Duke Energy Ohio
Case No. 19-1471-EL-BLN
STAFF Second Set of Data Requests B
Date Received: Wednesday, November 6, 2019

STAFF-DR-02-001 B

Attached as Staff-DR-02-001 B Attachment is a map showing existing lines and structures, proposed lines and structures, and the rail crossing, together with an identification of which poles are being replaced at the direct request of ODOT.

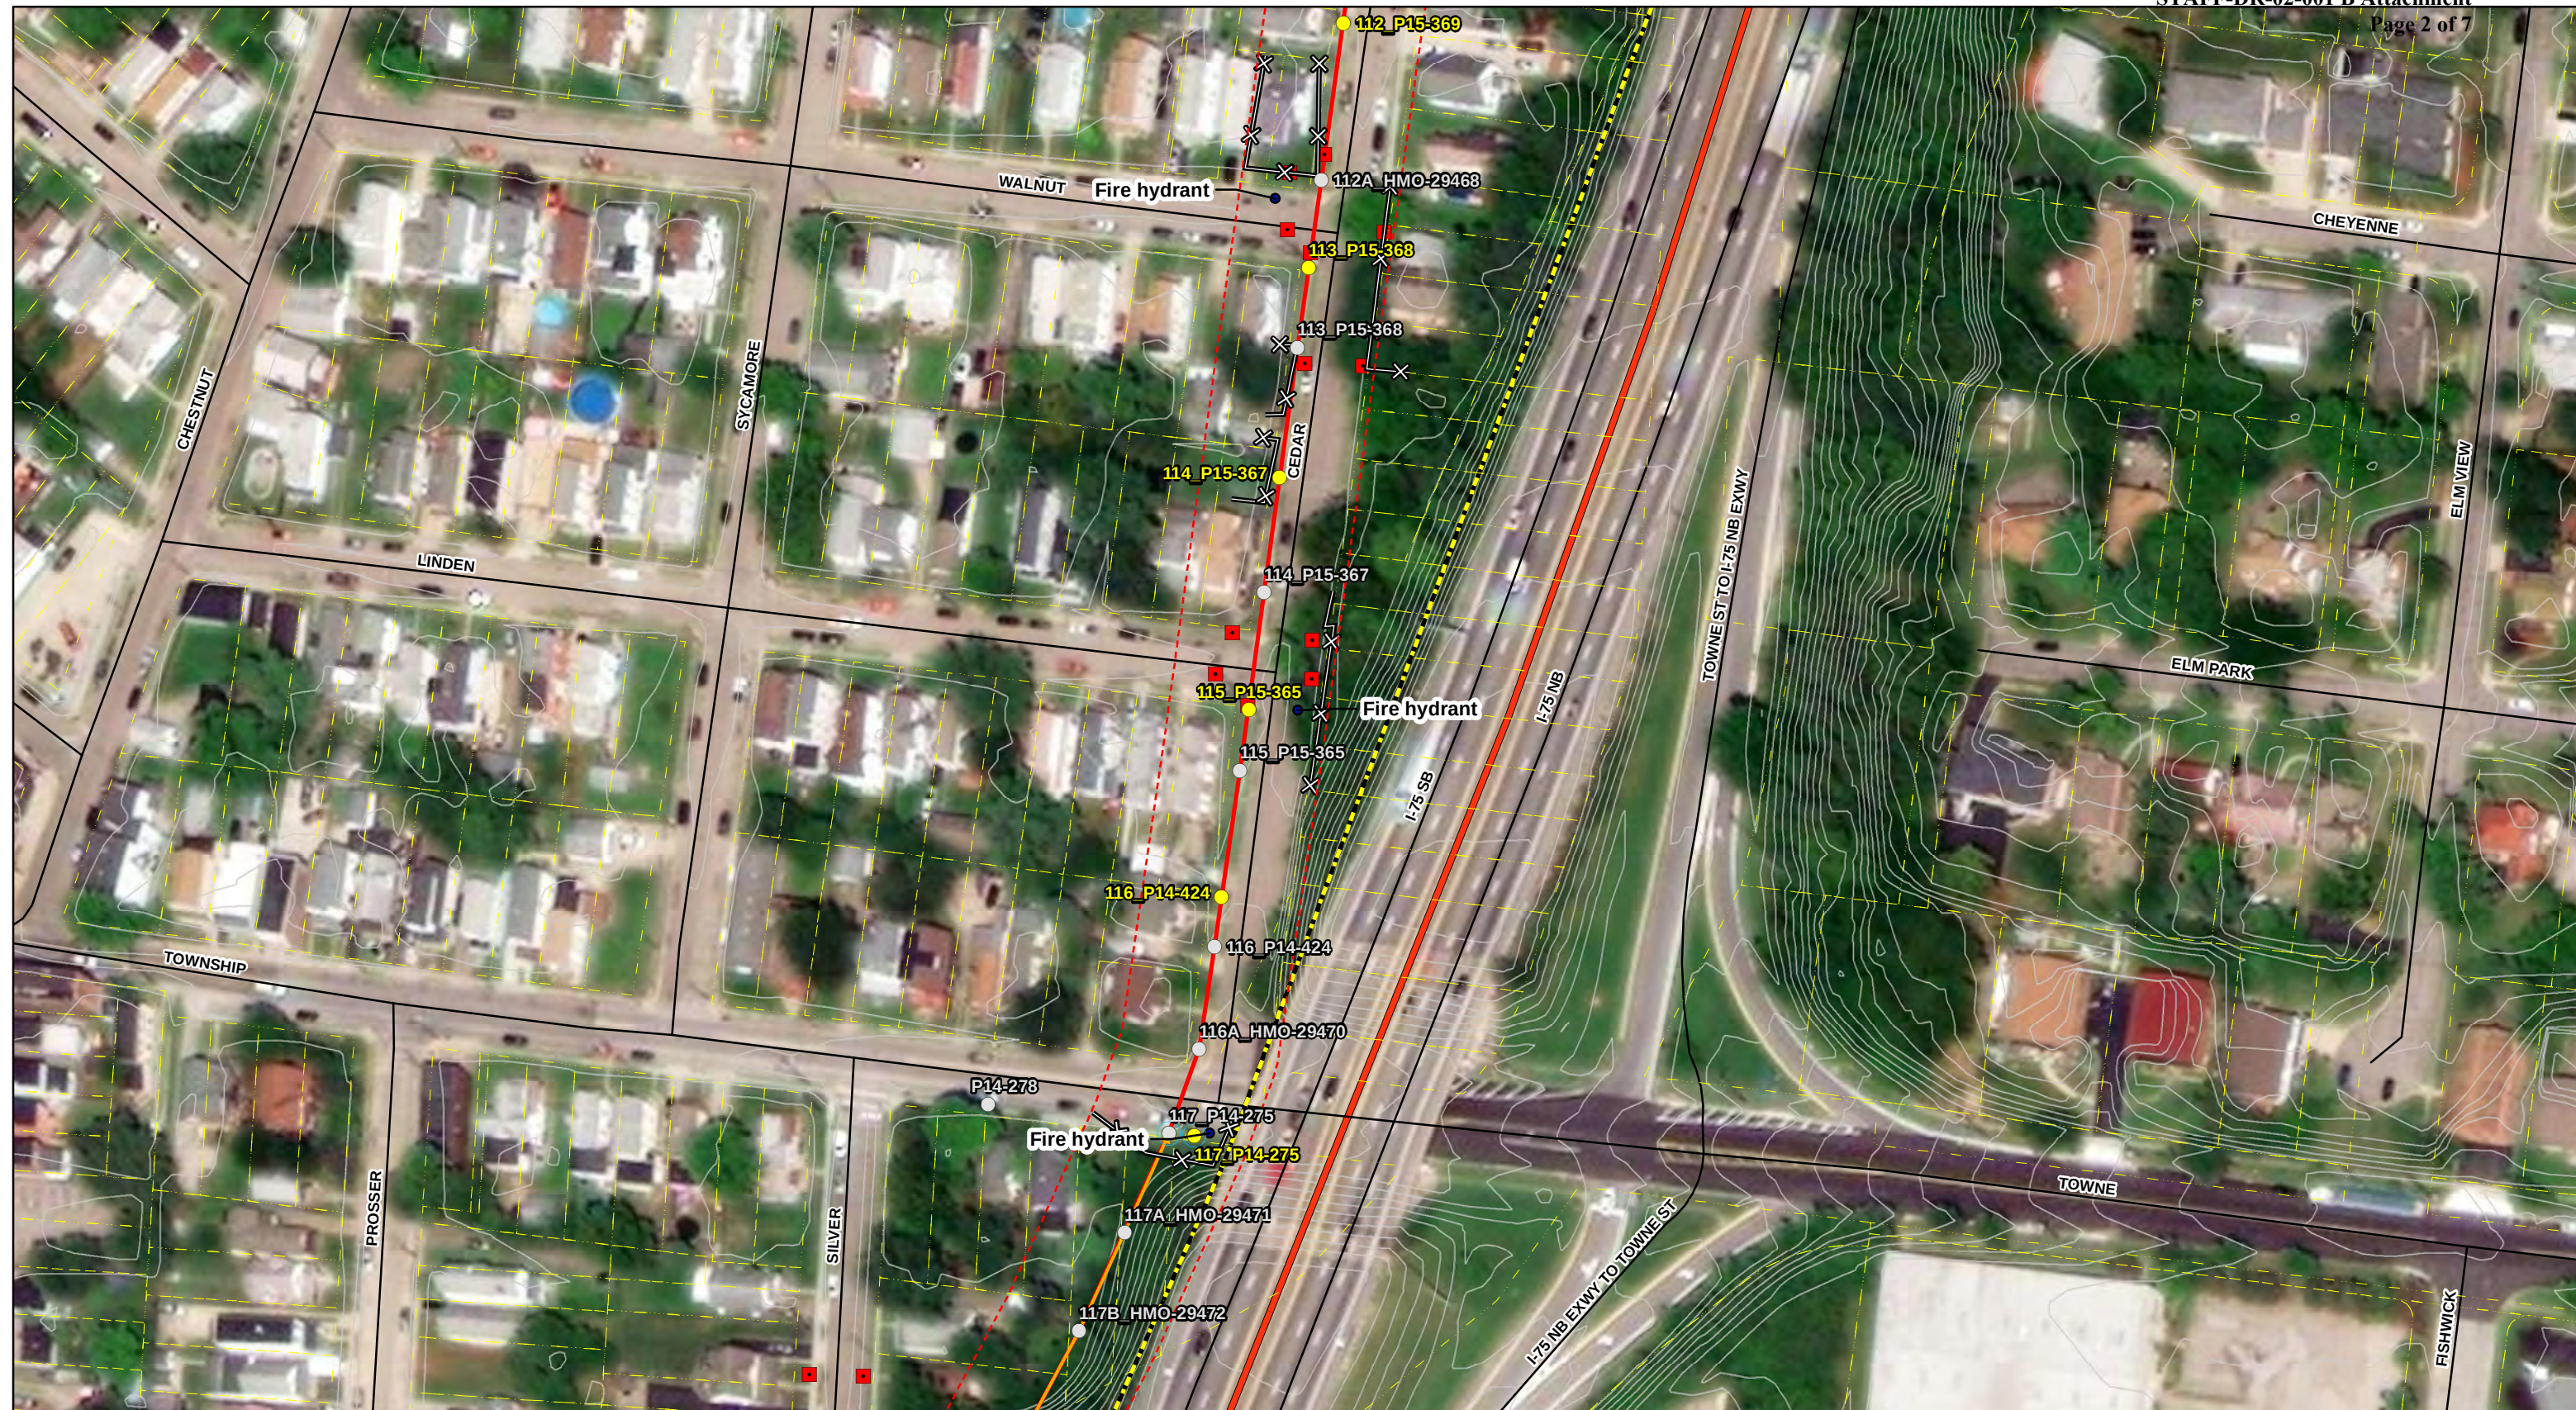
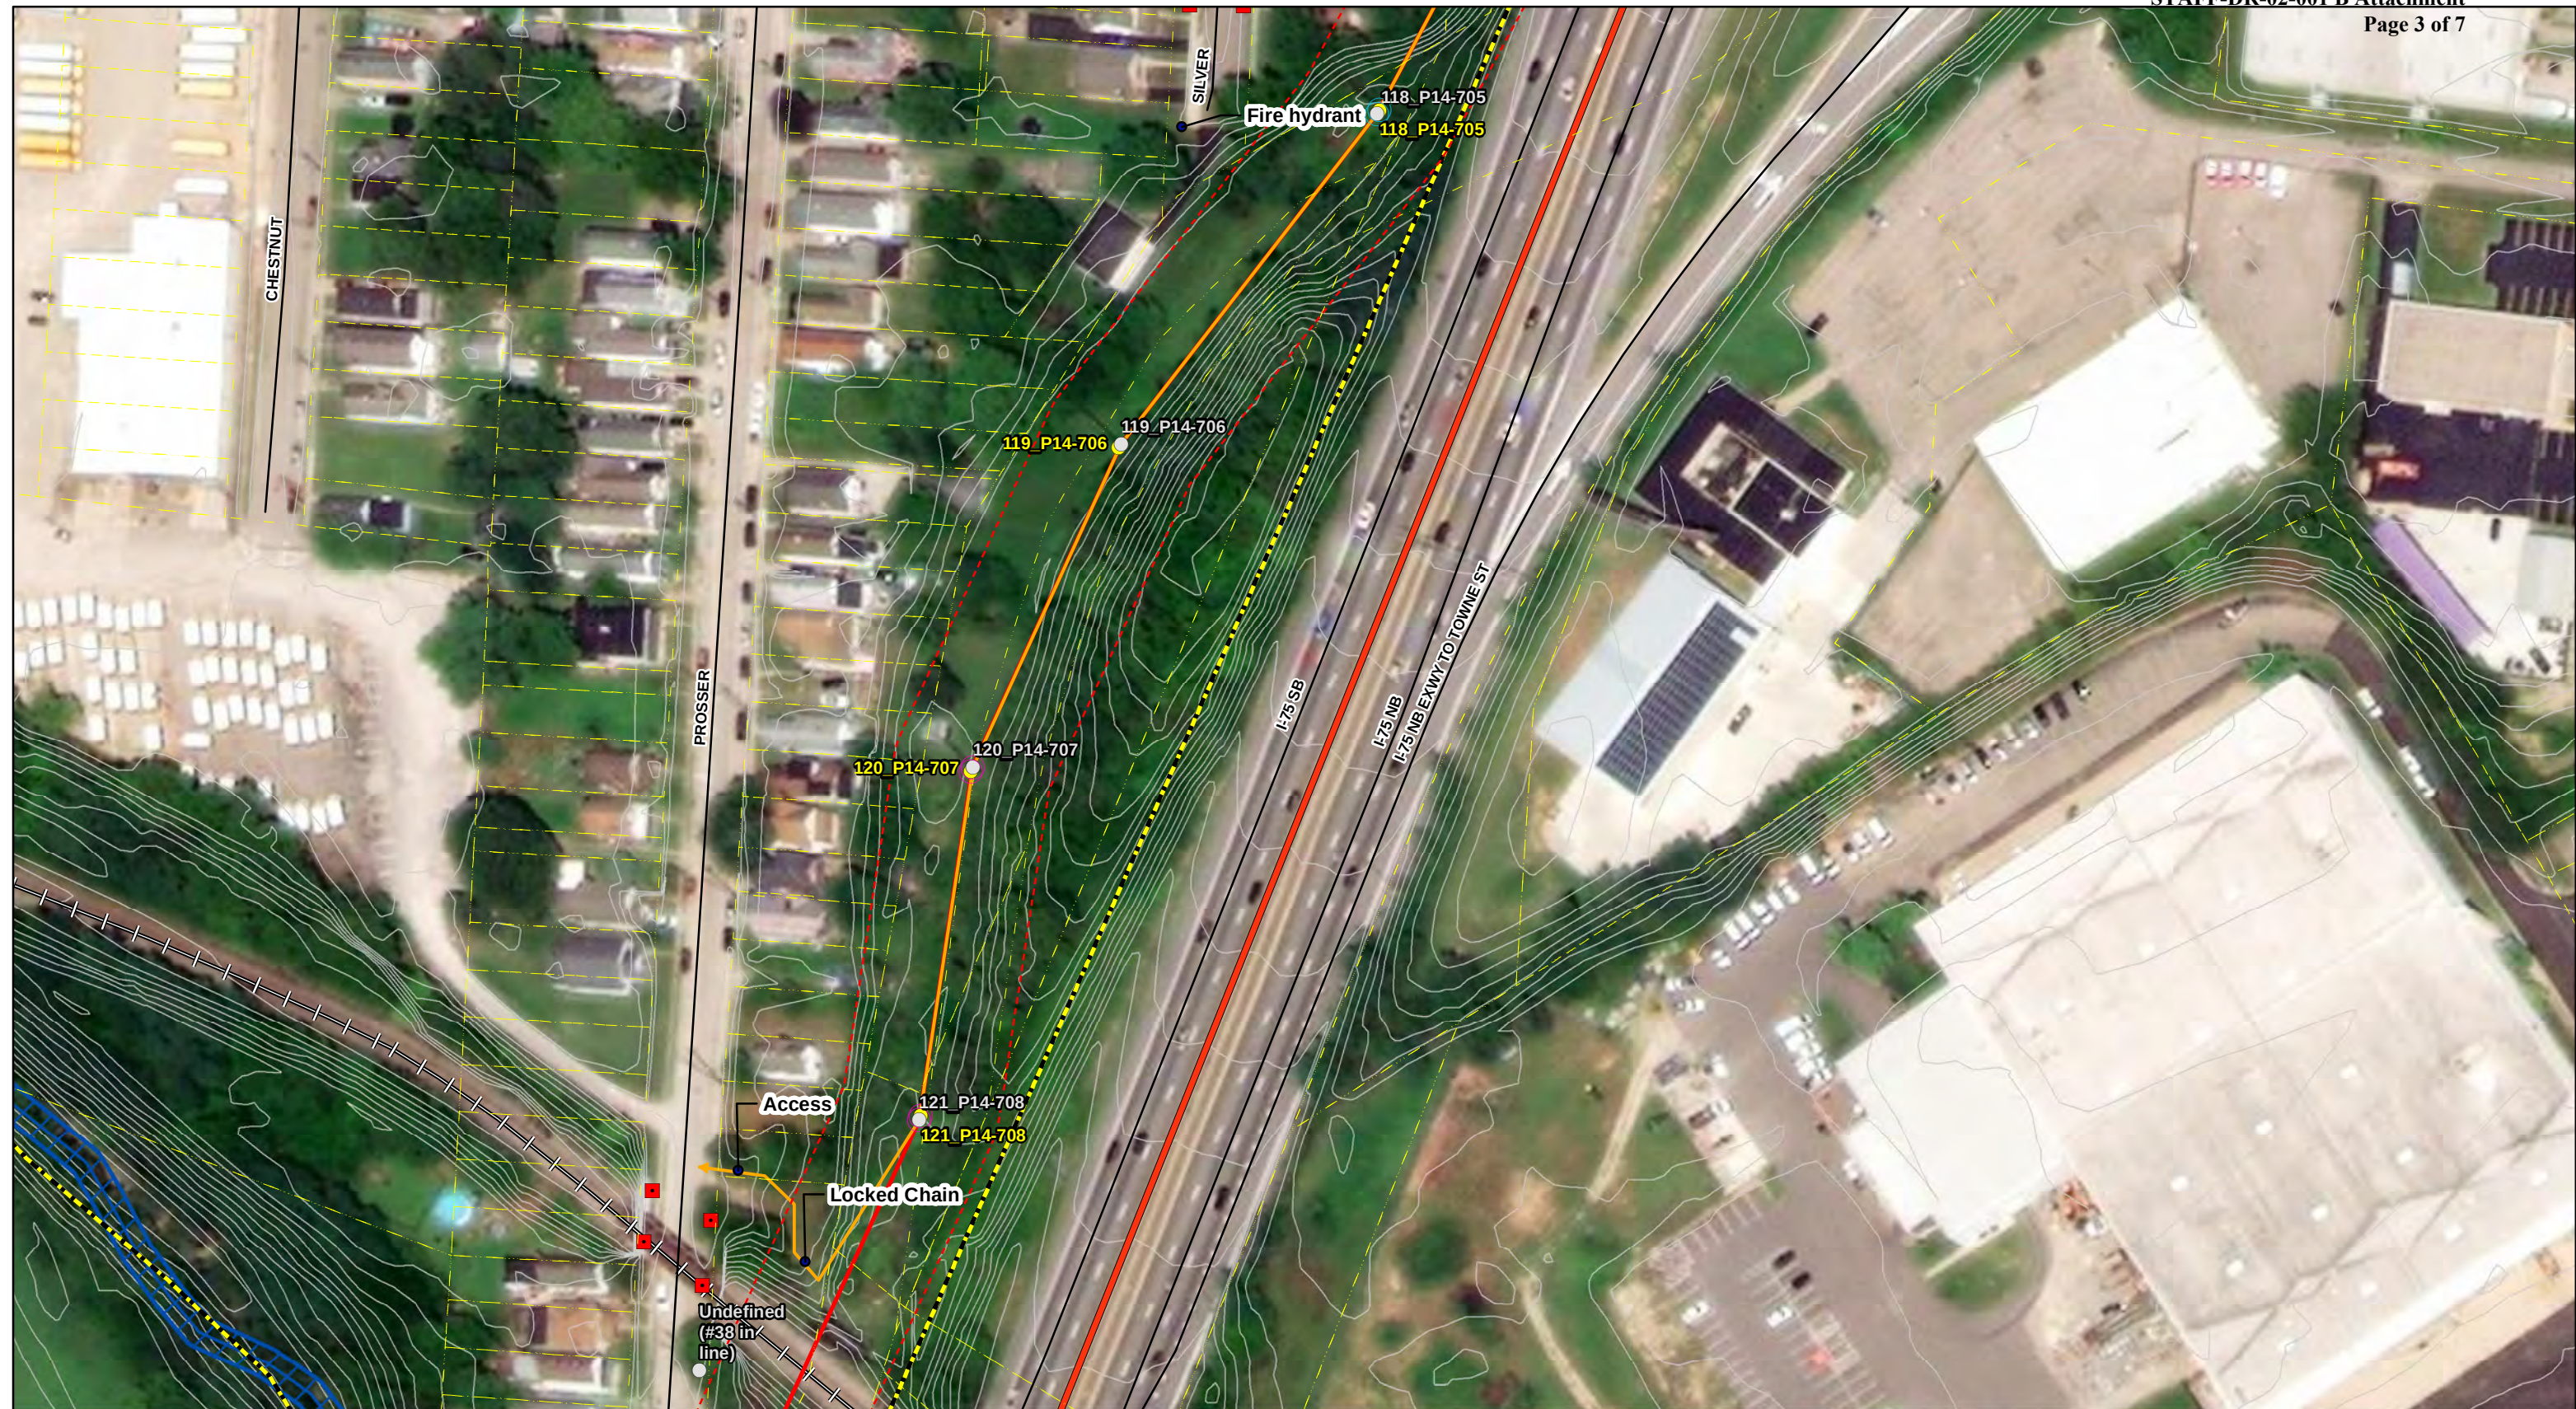
Staff is looking for clarification on the structures ODOT is requiring Duke to relocate, and the distances between the existing and new structure locations.

1. Can you provide to Staff the number of structures ODOT is requiring relocation of?
 - a. The structure numbers and a corresponding map for Staff to review of those structures, and the distances between the existing and new structures for Staff to review?

The following is a list of the reasons for changing the various poles involved in the project, impacted by : uplift and age

- A. These poles are required to move as far west as possible due to SR562 on ramp conflicts:
 - 684-P14-242
 - 684-P14-244
 - 684-P14-247
 - 684-P14-249
 - 684-P14-250
 - 684-P14-252
 - 684-P14-254
 - 684-P14-598
- B. These poles are required to be raised in height to accommodate anticipated future railroad crossing construction and operations:
 - 684-P14-707
 - 684-P14-708
 - 684-P14-709
 - 684-P14-168
- C. These poles are required to be moved West in addition to be raised vertically for construction clearances. ODOT plans to reconstruct the bridge structure.
 - 684-P14-275
 - 684-P14-705

D. These poles are in direct conflict with the proposed sound wall for I75:

- 684-P15-483
- 684-P15-647
- 684-P15-655
- 684-P15-656
- 684-P15-657

With regard to the remaining poles, the increased pole heights associated with the changes listed above require other nearby poles to also be replaced with taller poles. This is the basis for their inclusion in this project.

The following table sets forth, for each pole, whether it is a new pole or, if not, how far it will be from existing poles:

POLE NUMBER	DISTANCE FROM OLD POLE (FT)
103_P15-559	3
P13-560	3
P13-738	3
104_P15-490	3
105_P15-659	2
P15-661	3
106_P15-657	4
106A_HMO-29466	NEW POLE
107_P15-656	3
108_P15-655	4
109_P15-647	4
110_P15-483	3
110A_HMO-29467	NEW POLE
111_P15-352	3
P15-354	3
112_P15-369	31
112A_HMO-29468	NEW POLE
113_P15-368	52
114_P15-367	73
115_P15-365	39
116_P14-424	32
HMO-29469	NEW POLE
116A_HMO-29470	NEW POLE
117_P14-275	12
117A_HMO-29471	NEW POLE
117B_HMO-29472	NEW POLE
118_P14-705	5
119_P14-706	5

120_P14-707	3
121_P14-708	3
122_P14-709	4
123_P14-168	3
124_P14-568	29
125_P14-567	3
126_P14-400	4
127_P14-254	12
128_P14-252	34
129_P14-250	92
129A_HMO-29473	NEW POLE
130_P14-249	39
131_P14-247	94
132_P14-244	21
132A_HMO-29474	NEW POLE
132B_HMO-29475	NEW POLE
133_P14-242	9
133A_HMO-29485	NEW POLE
134_P14-598	4
135_P14-575	3
136_P13-117	3
137_P13-497	6
138_P13-111	5
